# SUNSET VILLAGE FILING NO. 4

## CONSTRUCTION PLANS

MODIFIED FOR S.I.A. CD SET  
RICHARD D. LYON, PE  
ATWELL, LLC  
DECEMBER, 2021  
EPC PROJ.: CDR-21-008

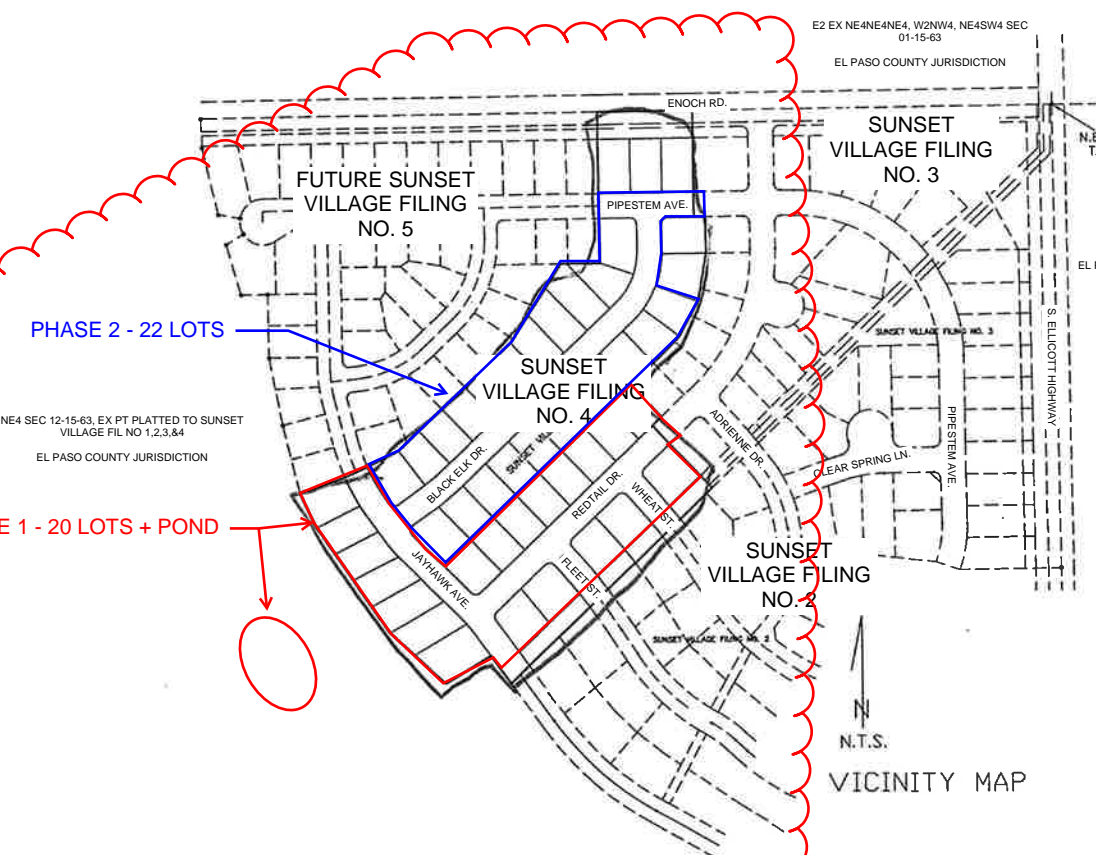
Please note that per the County Attorney's Office a condition of approval will be included with the construction plans.

Approval will be limited to phase 1 improvements only.

The construction plans will need to be resubmitted for review/approval once the developer intends to proceed with phase 2. Financial Assurance for phase 2 improvements will be required at that time.

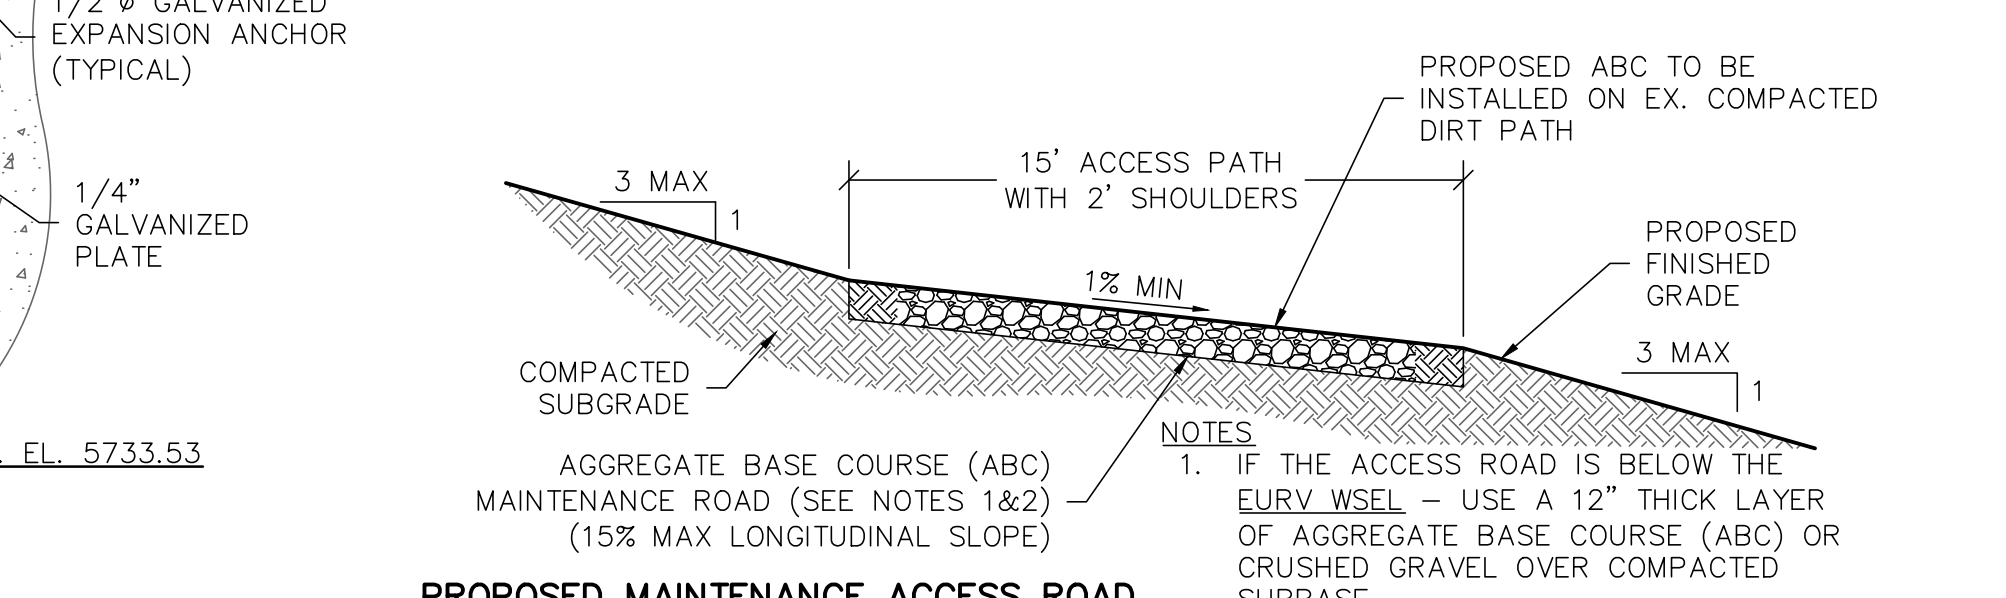
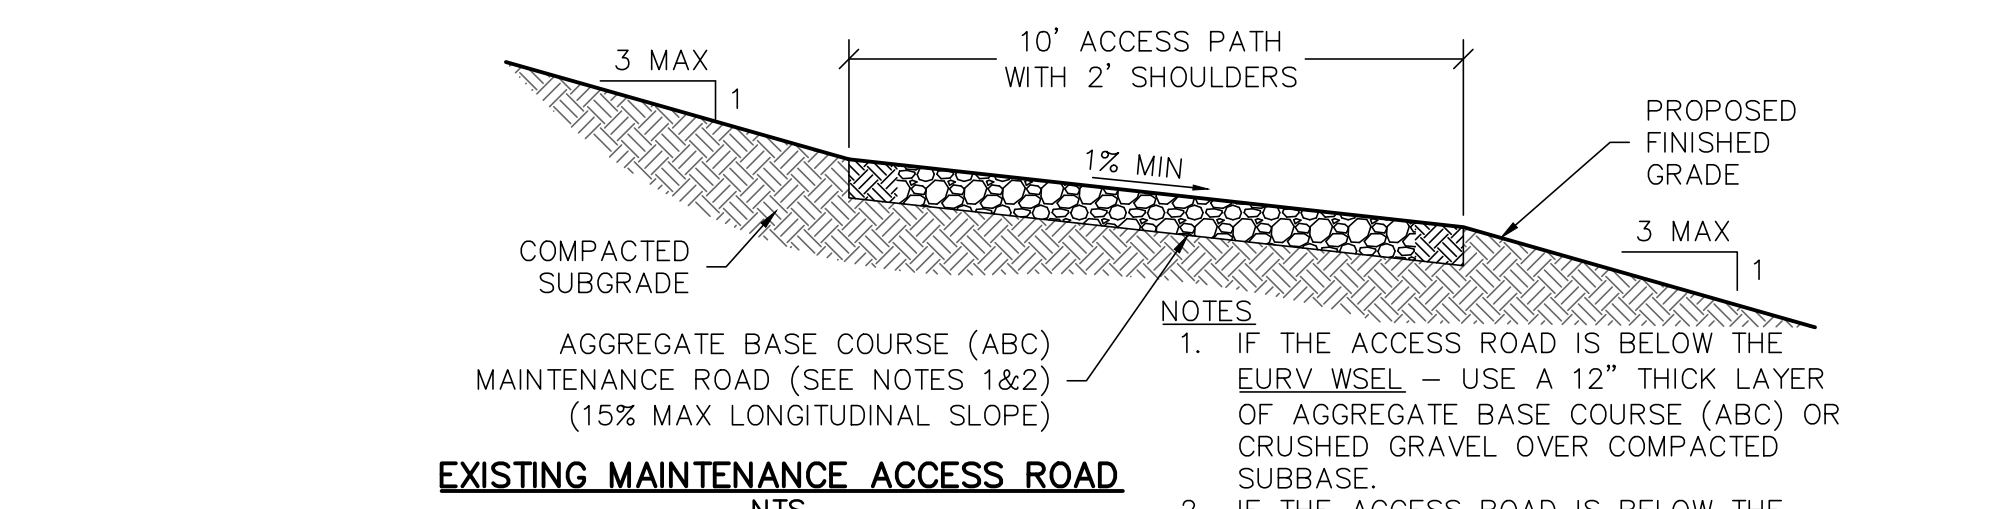
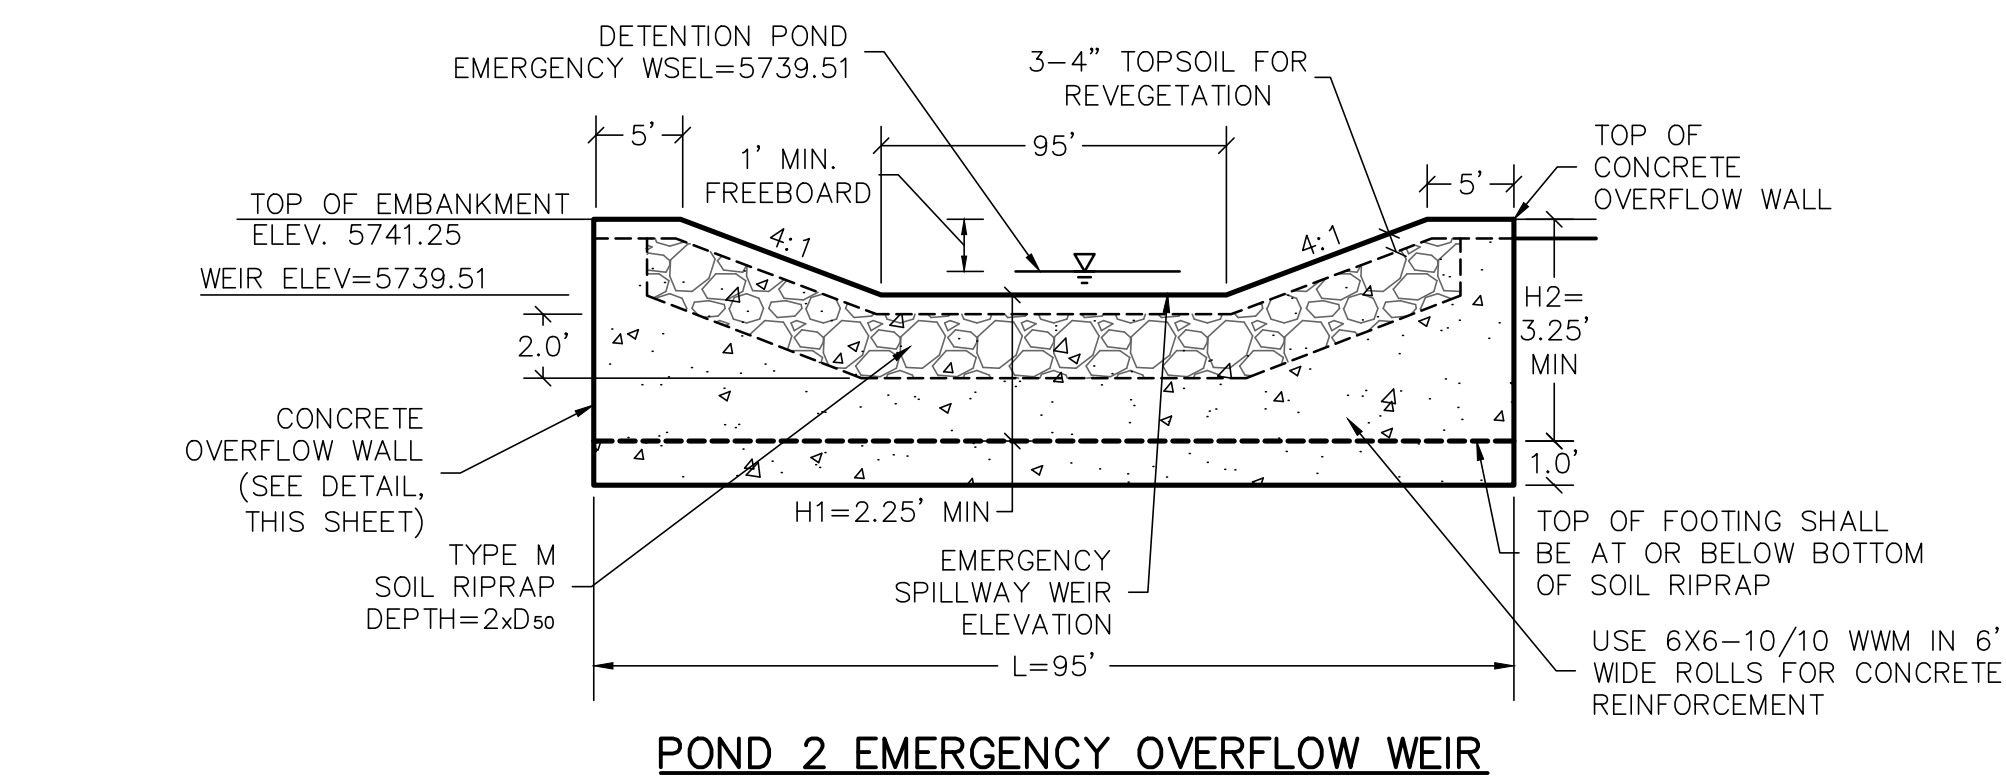
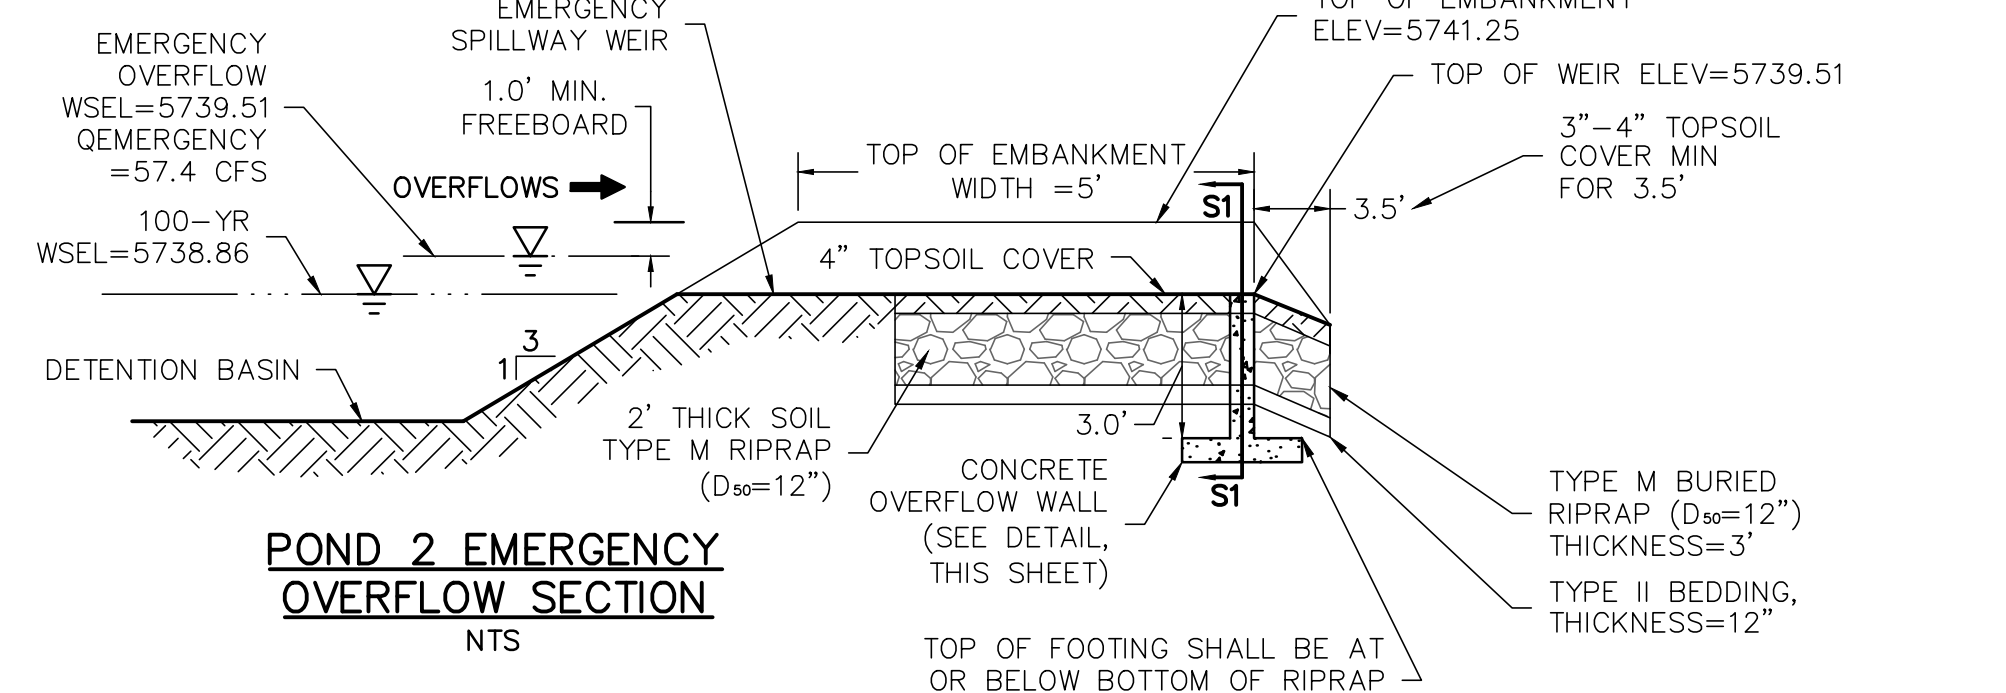
Revise to 8" per the MHFD-Detention worksheet.
